REMARKS

Appl'n No.: 09/777,555
 Title: Application Specific Traffic.....
 Inventors: Kevin L. Farley, et al.
 Annotated Marked-Up Drawings

Fig. 7

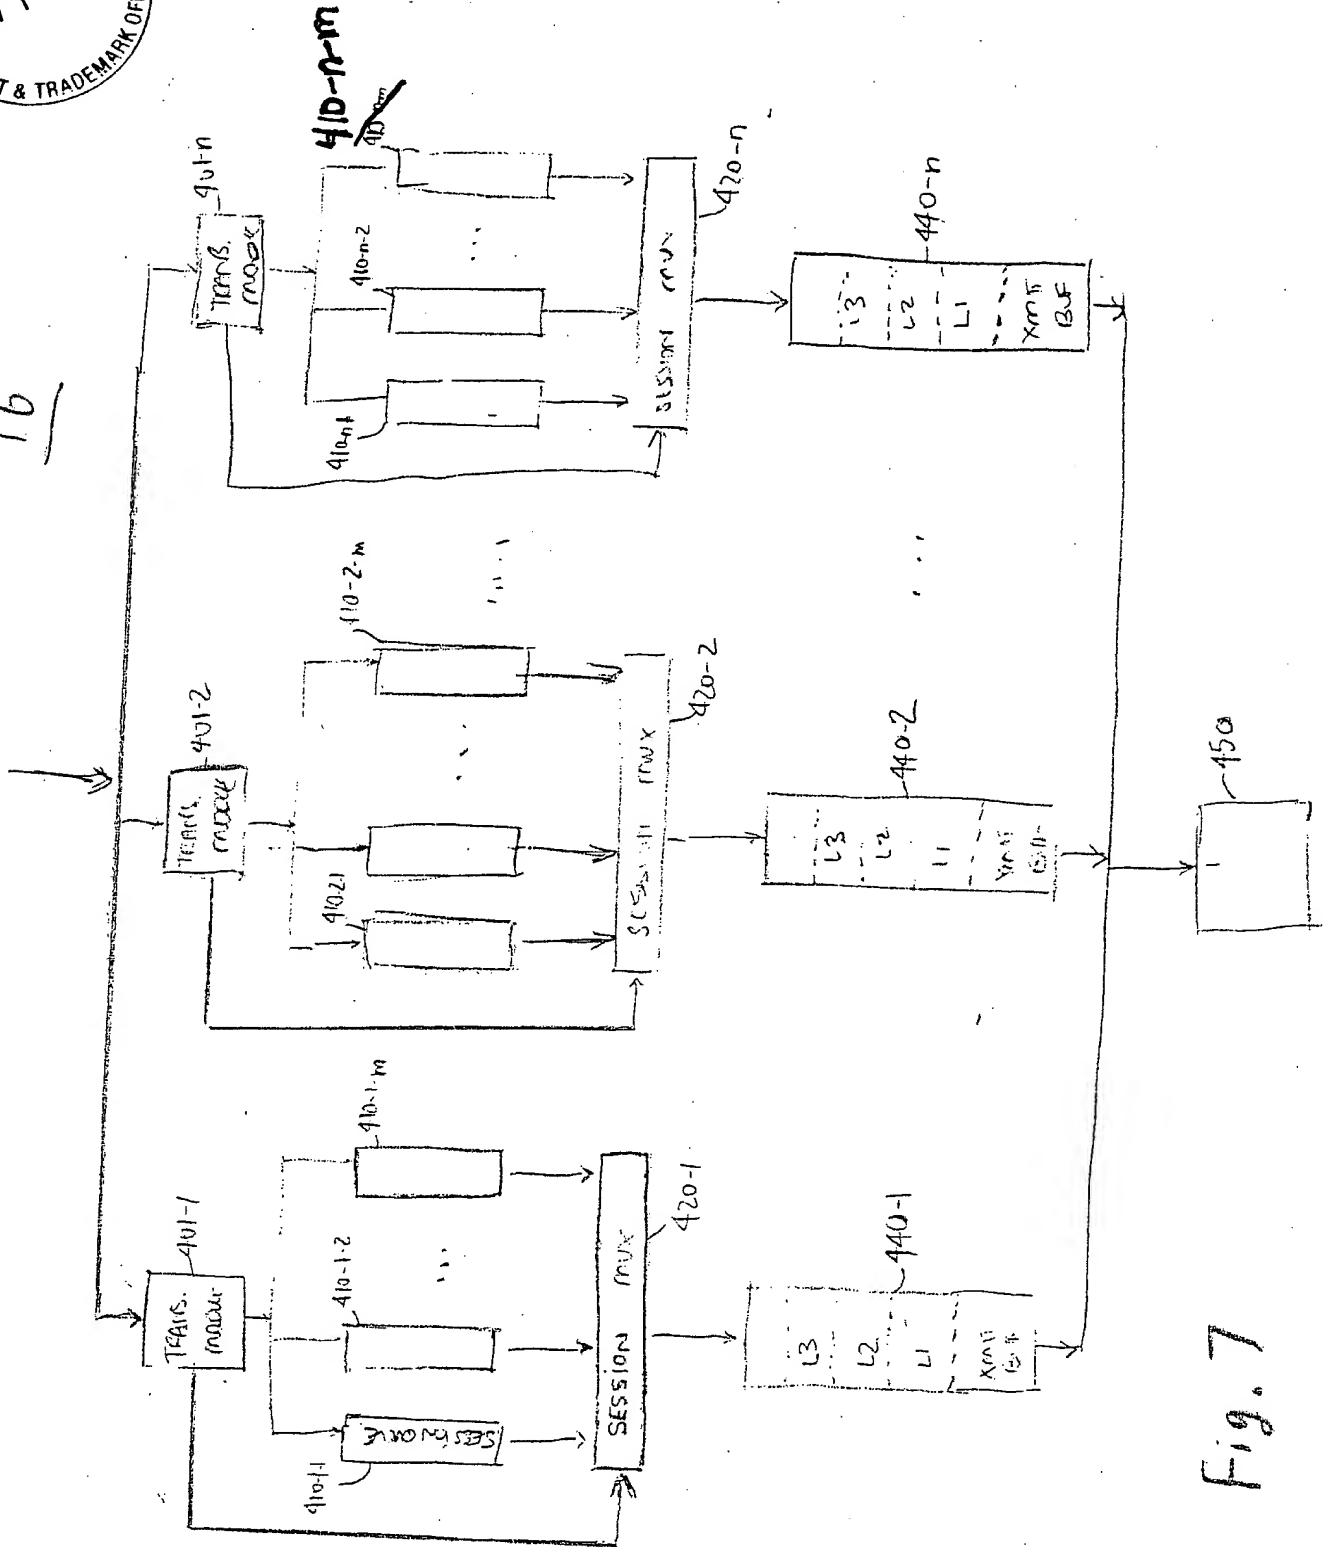
The Examiner objected to the drawings because the labels on Figures 6 and 7 were illegible. Applicants are providing replacement sheets 1-9 that include formalized drawings corresponding to all of the figures.

The Examiner objected to the drawings because reference 110 mentioned on page 9 line 19 of the specification as originally filed does not refer to radio links and does not appear in Figure 7. The specification has been amended to remove reference 110 from the specification.

The Examiner objected to the drawings because they do not include the following reference characters mentioned in the description: 34n, 54n, 410-n-m, 101-1.

Regarding reference character 410-n-m, the Applicants note that this reference character is used to identify the session queue in the far right of Figure 7. This reference character is more clearly shown in the replacement sheet 9 provided herewith.
